## Consultation on the proposed works to enable connection of additional onshore wind capacity at Coalburn Substation

Subject	Details
<b>Publication date:</b>	14 March 2022
<b>Response deadline:</b>	11 April 2022
<b>Contact</b>	Eliska Antosova, Senior Analyst
<b>Team:</b>	RIIO Electricity Transmission
<b>Telephone</b>	020 7901 7176
<b>Email:</b>	Eliska.antosova@ofgem.gov.uk

We have engaged with the ETOs on the potential MSIP projects to be submitted in this first MSIP re-opener window. This document summarises the submission received from SPT for the proposed connection of the additional onshore wind capacity at Coalburn Substation MSIP project.

**Figure 2: Summary of works required – single line diagram**

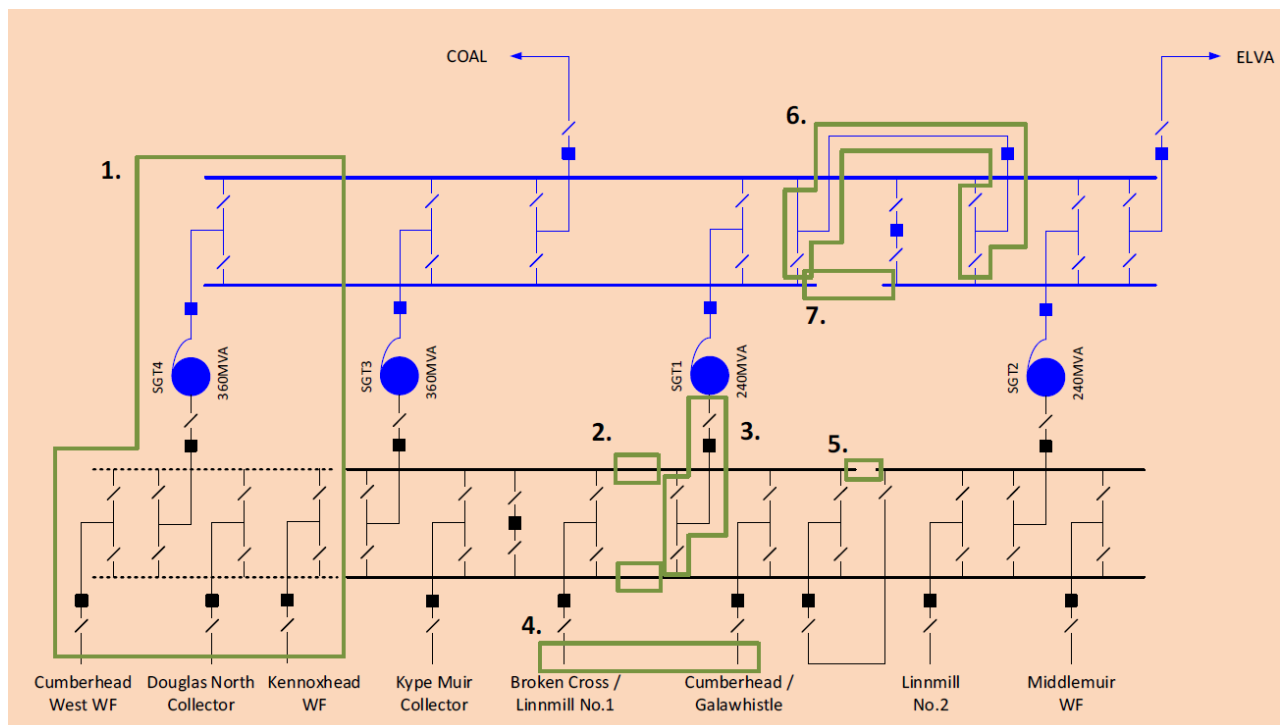
5.8. Figure 2 below indicates the works summarised below on the proposed single line diagram for Coalburn 400/132kV Substation:

1. Extend the existing substation fence line to accommodate extensions to the 132kV and 400kV busbar systems, install one new 400/132kV 360MVA SGT, one new 400kV and one new 132kV double busbar transformer bay.
2. Split existing 132kV main and reserve busbars to create two separate 132kV busbar systems.
3. Realign the SGT1 132kV bay.
4. Realign the Galawhistle Wind Farm and Linnmill No.1 cable systems.
5. Install a section of 132kV Main Busbar (adjacent to Bus Coupler CB120) to establish a double busbar configuration.
6. Decommission the existing 400kV cross coupler.
7. Install a section of 400kV Main Busbar adjacent to the bus.
